Zoning Ordinance Approval
CITY OF AUSTIN
RECOMMENDATION FOR COUNCIL ACTION

SUBJECT: C814-90-0003.13 - Harris Branch PUD Amendment #13 - Approve second/third readings of an ordinance amending Chapter 25-2 of the Austin City Code by rezoning property located at 1375 U.S. Highway 290 East at Proposed State Highway 130 (Harris Branch, Gilleland Creek, Decker Creek Watersheds) from planned unit development (PUD) district zoning to planned unit development (PUD) district zoning to change a condition of zoning. First reading approved on October 27, 2005. Vote: 6-0, Council Member Alvarez off the dais. Applicant: Austin HB Residential Properties (John McCullough). Agent: Minter, Joseph & Thornhill, P.C. (John M. Joseph). City Staff: Sherri Sirwaitis, 974-3057.

ZONING CHANGE REVIEW SHEET

P.U.D. LAND USE PLAN

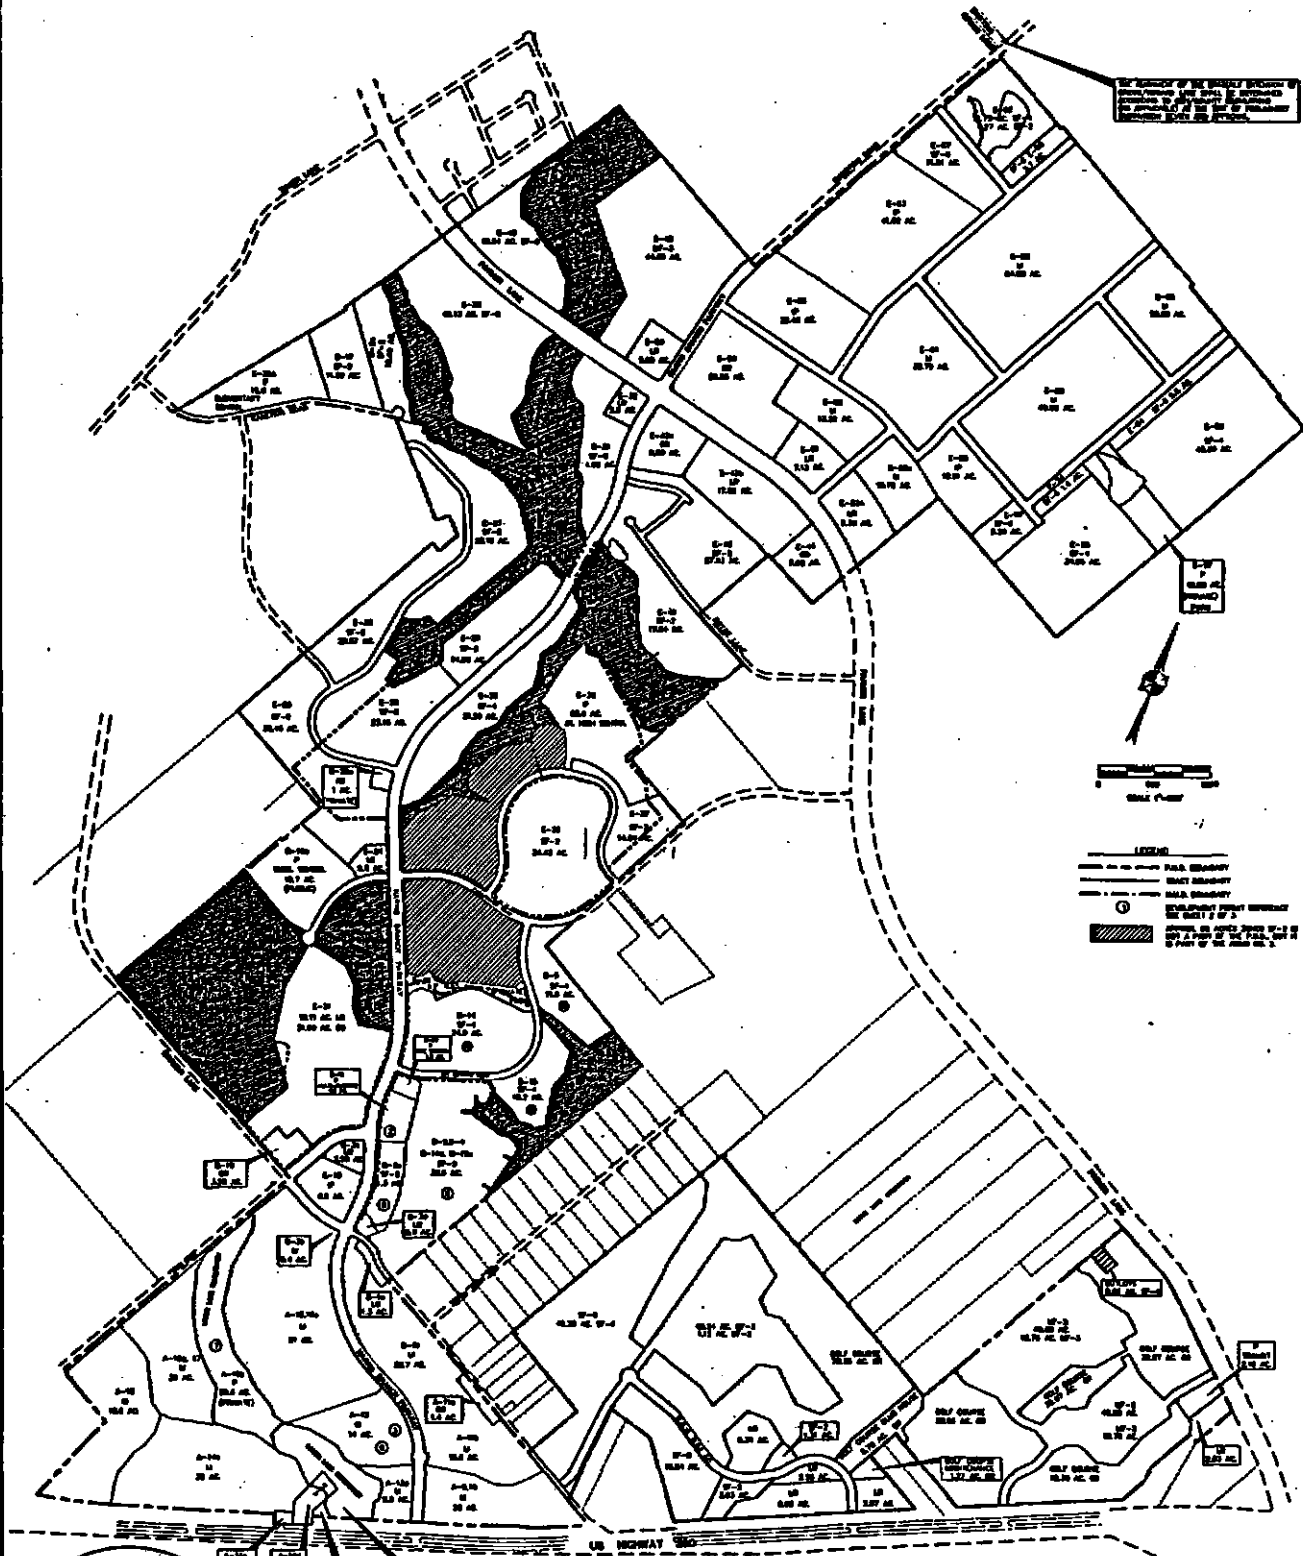
It is difficult to tell on sheet 2 of the PUD plan what has changed, since Revision 13 is with 11 & 12, and the changes were not clouded.

Please redline the approved Harris Branch PUD Land Use Plan to directly show the proposed changes for the PUD. Please redline the PUD Densities Tables - Sheet 2 to display how the proposed revisions to Tracts SG-1 through SG-14 will affect the breakdown of uses and within the PUD. Please provide information concerning the how the proposed land use changes will affect the overall building coverage and impervious cover amounts within the PUD.

ZN-2 The Harris Branch PUD Land Use Plan has a "red line" drawn around the areas subject to this amendment. Attached Please see the revised Harris Branch Density Tables -- Sheet 2 showing the effect on building coverage and impervious cover.
